Access Compliance Report Public Rights-of-Way (Pedestrian Signals)

Main Street: **NEWPORT_AVE** Cross Street: **FOOTHILL_BLVD** Location: **W**

ADA ID: **SGAT211018093332** Signal Type: **One Push Button-Non APS** Overall Compliance: **No** Severity Scores: **BTN 1: 25** **BTN 2: N/A** **No BTN: N/A**

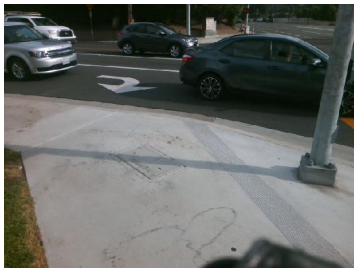
OC Std/PROW: **R404.2**

Possible Solutions: Remove and Replace Clear Space.
